SUBJECT: SUMMARY OF MAY 3, 2012, PUBLIC MEETING OF THE
NUCLEAR REGULATORY COMMISSION TO DISCUSS FIRE
PROTECTION CIRCUIT FAILURES AND OTHER CURRENT
LICENSING BASIS ISSUES

NRC STAFF COMMENTS ON NEI 00-01, REVISION 3

Summary of NRC's comments on NEI's changes to Chapter 3 and Appendix G of NEI 00-01.

**Figure 3.5.2-7 - Inter-Cable with Ground Plane
[Same Raceway]**

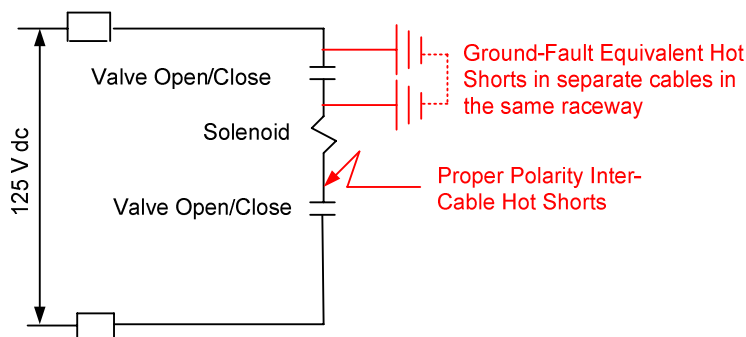
C184. *Clarification* - Do not limit this to the same raceway.

Figure 3.5.2-11 - DC Motor – Motive power

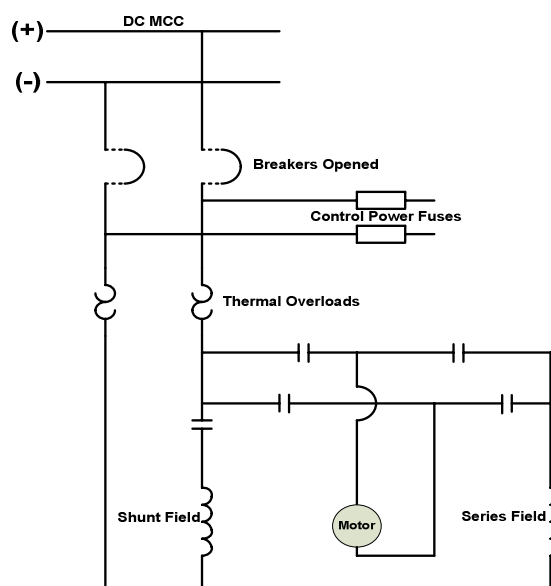
C192. *Clarification* - RG 1.189 states, "For ungrounded dc circuits, if the licensee can show that at least two hot shorts of the proper polarity without grounding are required to cause spurious
